## **ADDENDUM NO. 2**

### **2014 - Cemetery Road Bridge Replacement**

**Essex County, NY**

**May 29, 2014**

**NORTH ABUTMENT ELEVATION**  
1/4\"/>

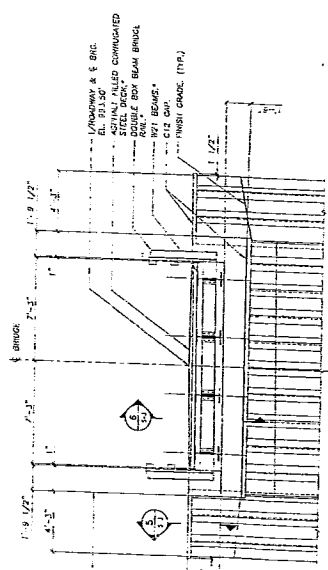
5. **Regarding Drawing S-2:** *North Abutment Elevation* - CHANGE T/Headwall Elevation indicated from 992.39 to 993.39.
